Special Village Plan Commission / ZBA Meeting Agenda

5. PUBLIC HEARING AND RECOMMENDATION TO THE VILLAGE BOARD ON AN APPLICATION FOR A SPECIAL USE CONCERNING THE PROPERTY LOCATED AT THE NORTHWEST CORNER OF ROUTE 72 AND CENTER DRIVE (02-24-155-003)

Re: Red Barn Animal Hospital
Preliminary Plan Submission
Review #1

TO: Brian Bourdeau, Village Administrator
FROM: Kevin J. Biscan, PE, PLS, Consulting Engineer
DATE: March 3, 2022
RE: Red Barn Animal Hospital
Preliminary Plan
REL #22-R0333
Review #1

SHEET NUMBER
L-1.0

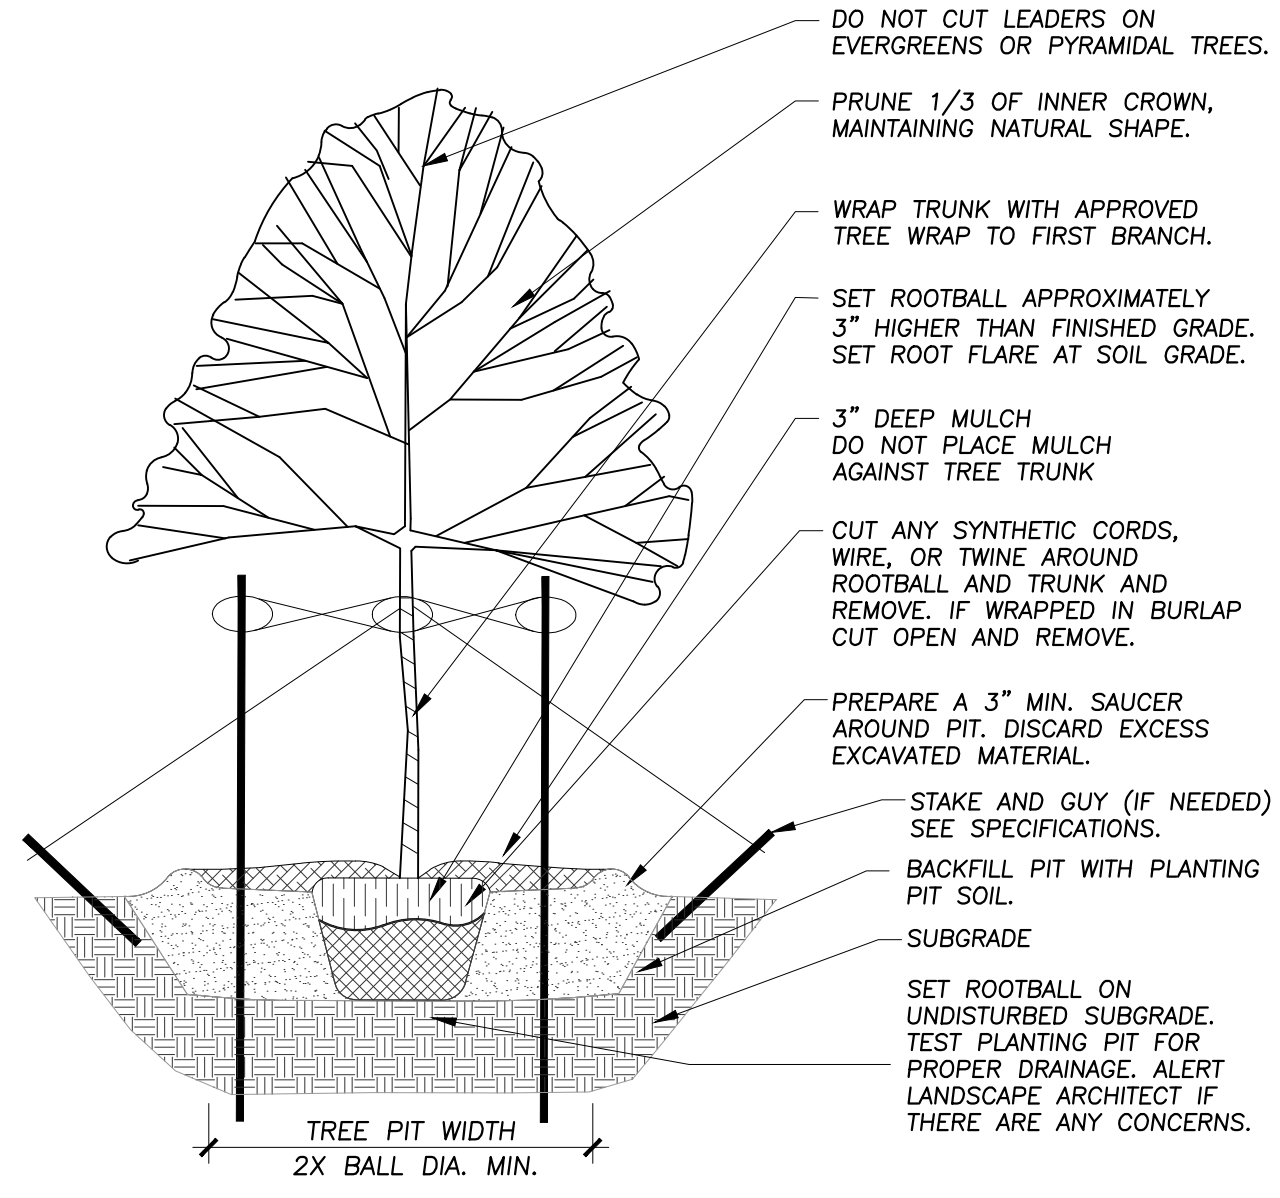
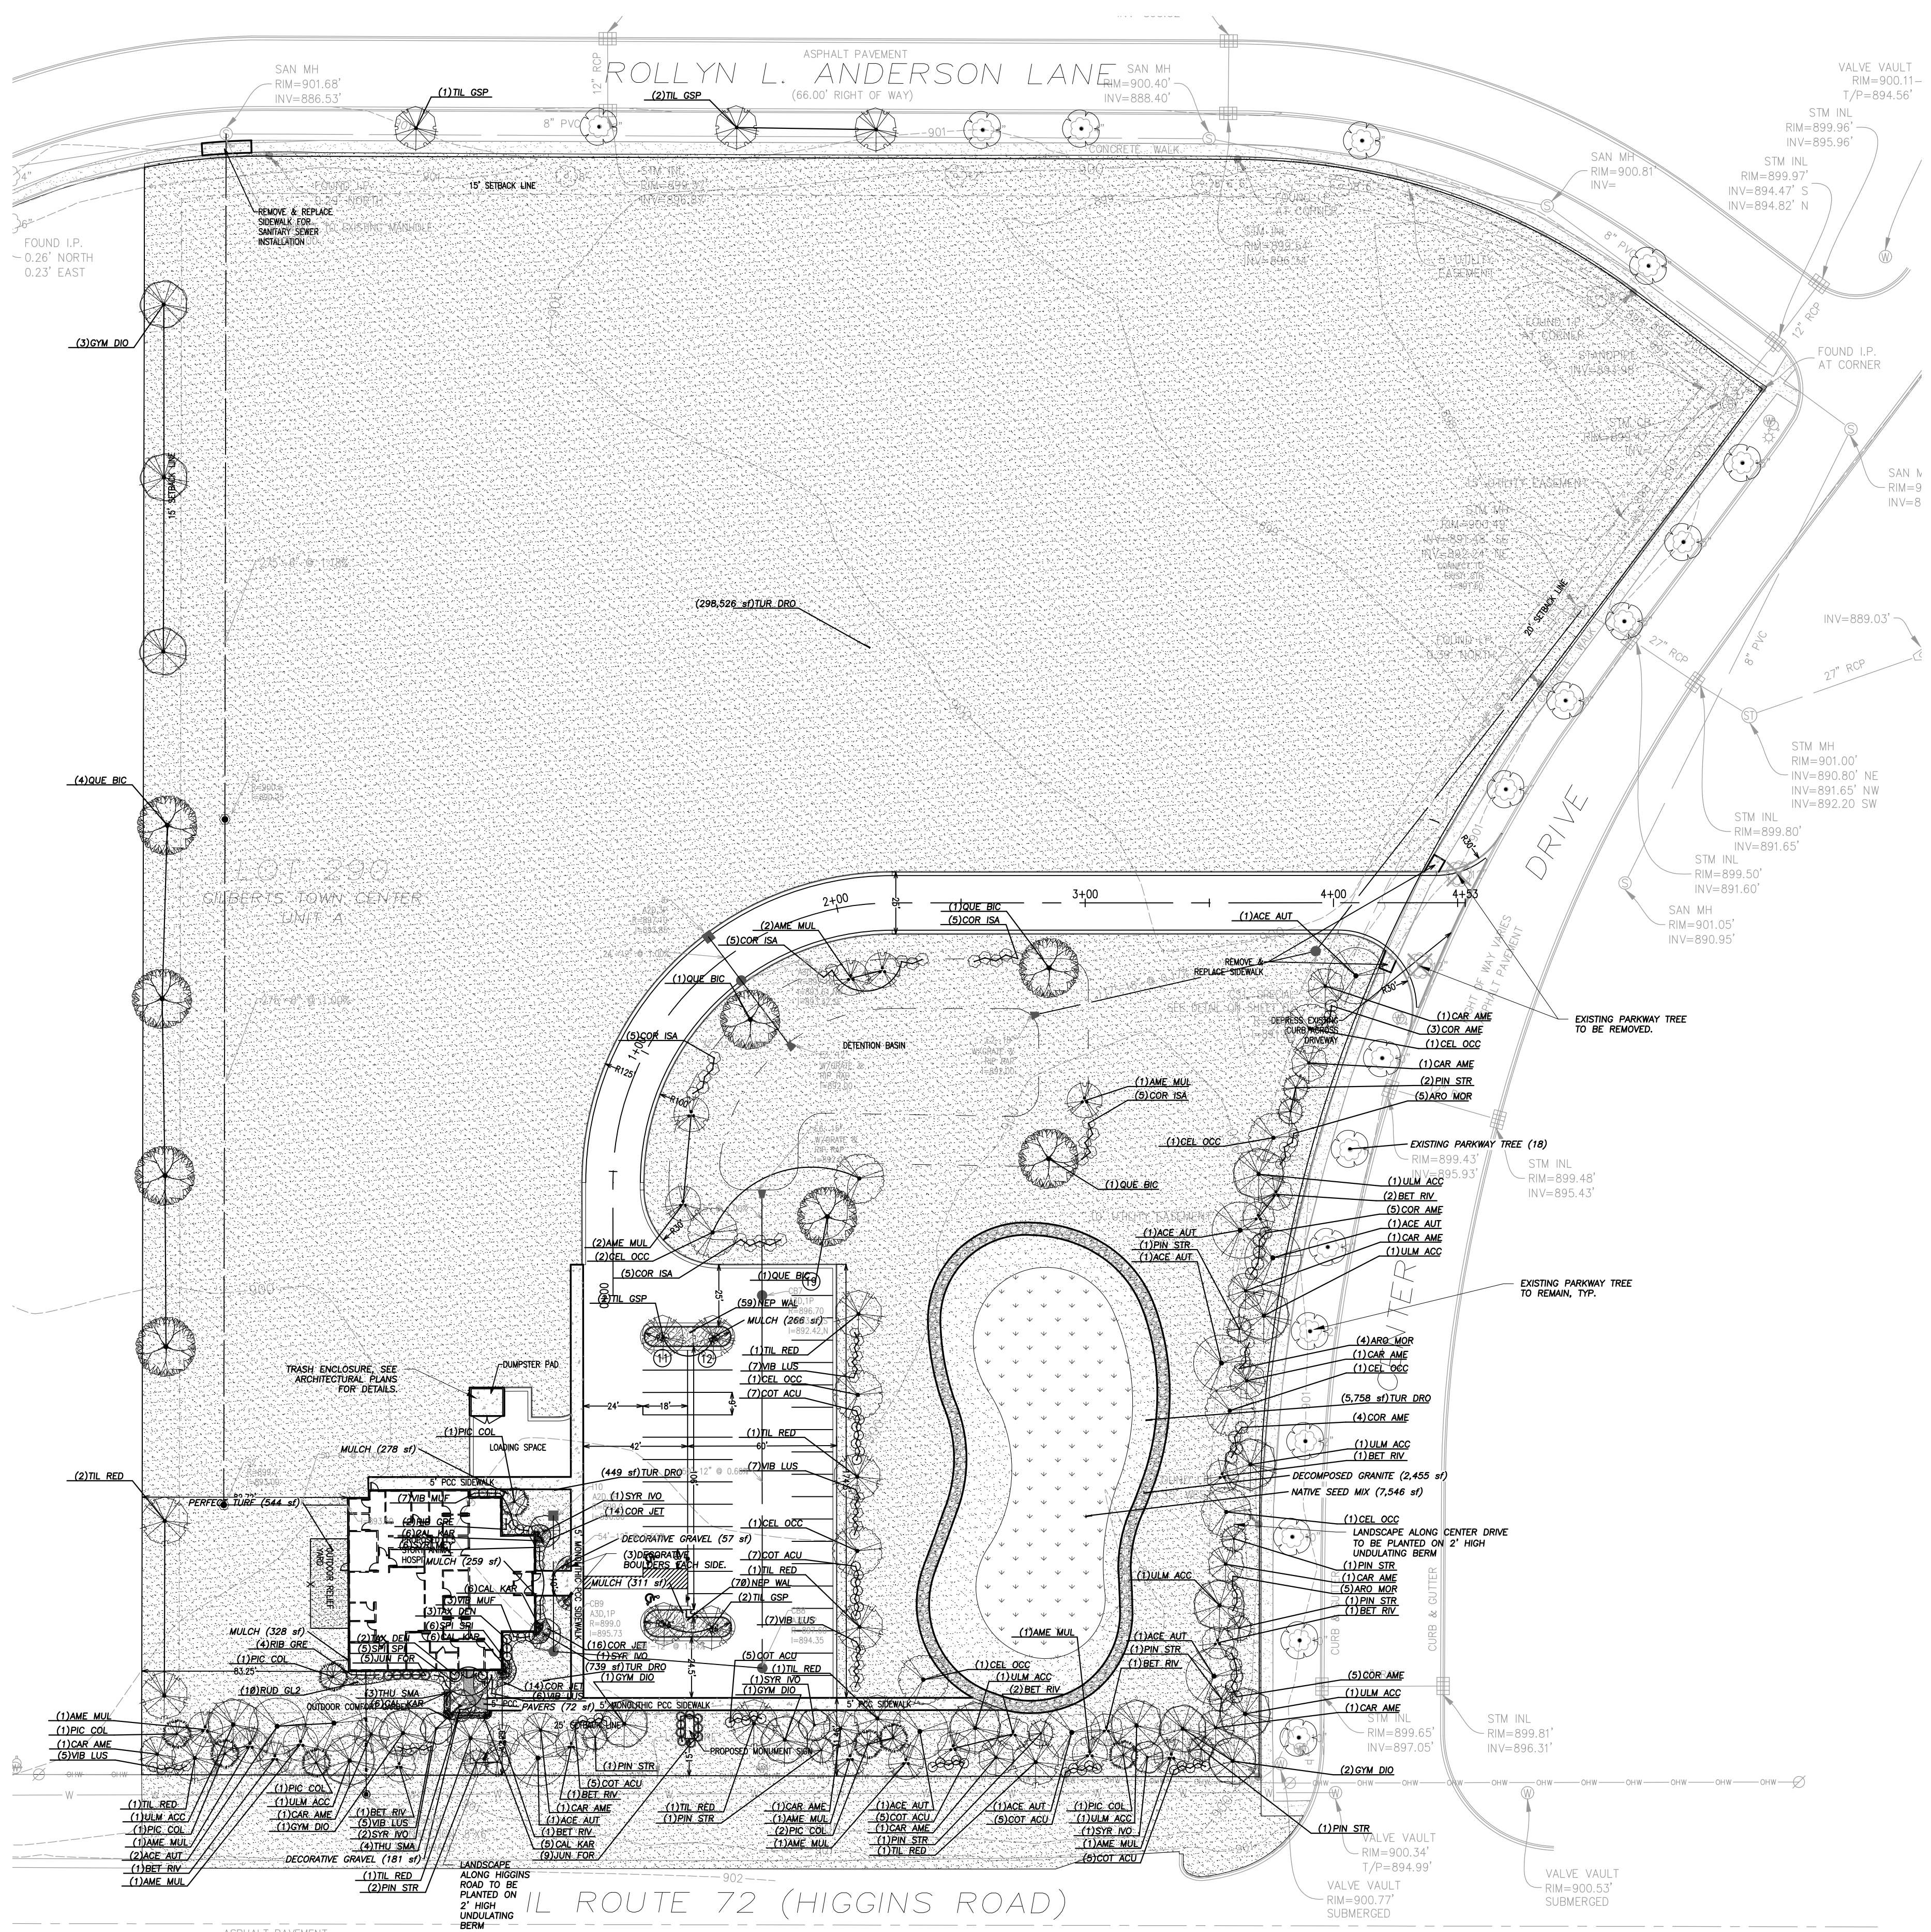
10. Show the existing parkway trees on all sheets in the improvement plans.
 - Existing parkway trees shown on L-1.0
11. Provide dimensions for all radii in the parking lot and entrance drive.
